■ Letter 85: Arc Ecology (1/12/10)

RE: Public Comment on Candlestick Point-Hunters Point Shipyard Phase II Development Plan Project (formerly the "Bayview Waterfront Project") Draft EIR [DEIR]

Arc Ecology is re-submitting our document **ALTERNATIVES FOR STUDY** as formal commentary on Candlestick Point-Hunters Point Shipyard Phase II Development Plan Project (formerly the "Bayview Waterfront Project") Draft EIR [DEIR].

HUNTERS POINT SHIPYARD + CANDLESTICK POINT | SAN FRANCISCO, CA  
**ALTERNATIVES FOR STUDY**  
DRAFT OUTLINE OF ISSUES, POSITIONS, AND ALTERNATIVES FOR PUBLIC COMMENT AND FURTHER STUDY

**FIGURE II-17**

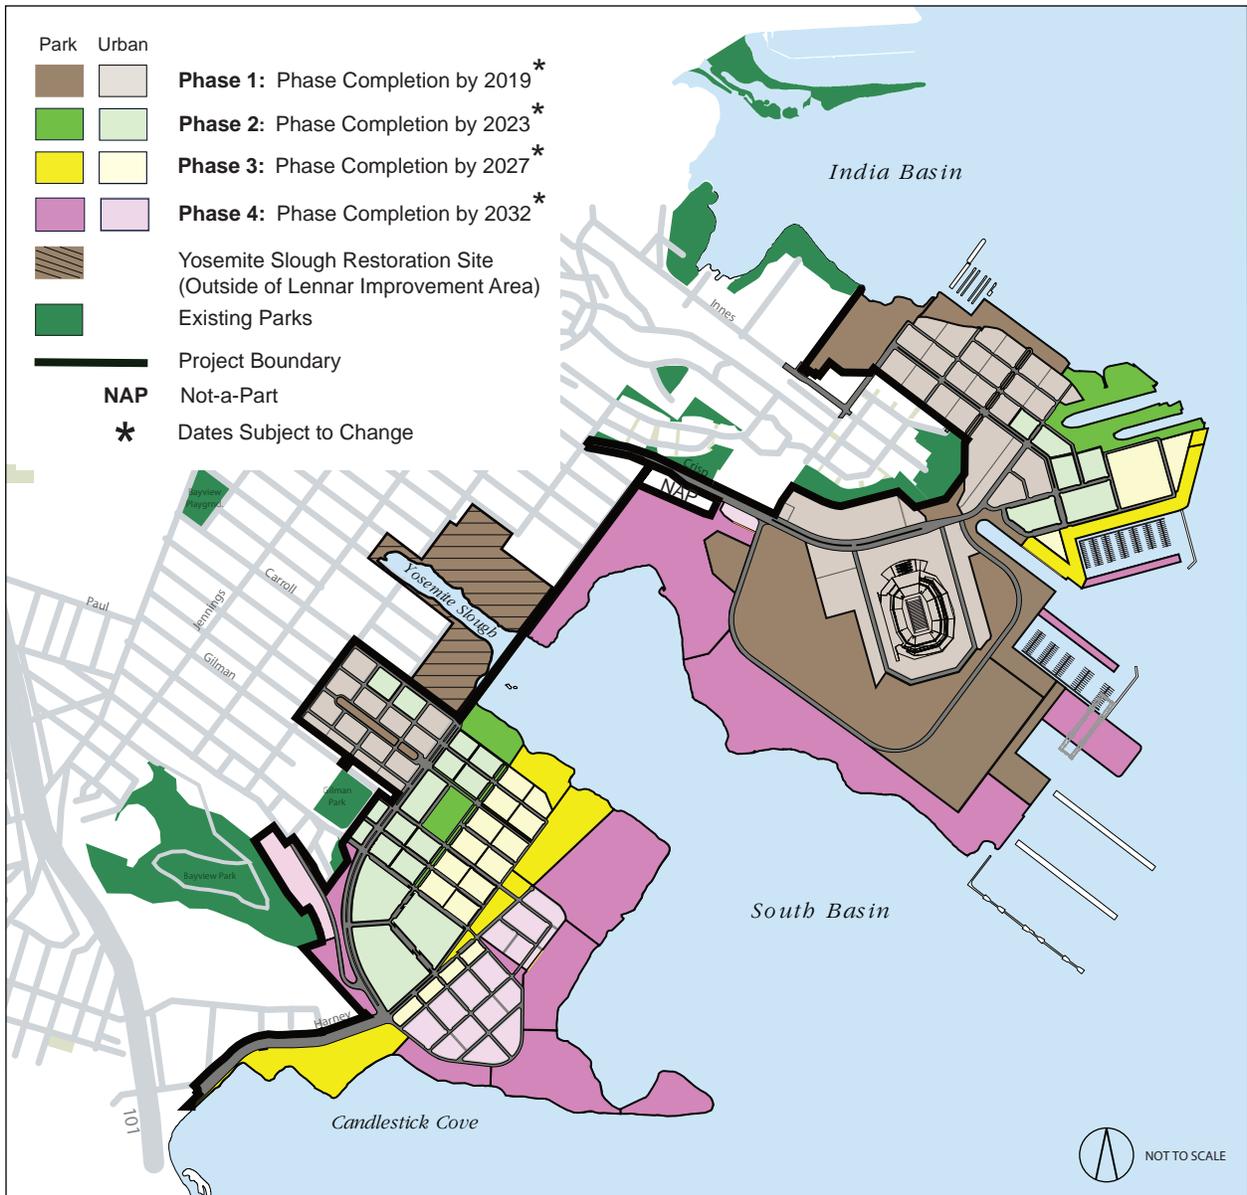
Comment E.2 Figure II-17 in Vol. II, pg 86 shows a timeline for development of parks on Candlestick Point SRA and HP Shipyard Phase II that extends through 2021 and 2025. California State Parks appreciated the City and Redevelopment Agency's suggestions about potential phasing of Candlestick Point SRA improvements. Decisions about improvement schedules at the SRA, however, will be made by California State Parks upon completion of the updated general plan for the SRA. The EIR should be revised to clarify that Figure II-17's suggestions for Candlestick Point SRA's improvement are for illustrative purposes only, and may be altered as needed by California State Parks.

In response to the comment, Figure II-17 (Proposed Building and Parks Construction Schedule) indicates that the completion dates are estimated and subject to change. CPSRA improvements outside of the control of Lennar Urban may be completed as determined appropriate by California State Parks.
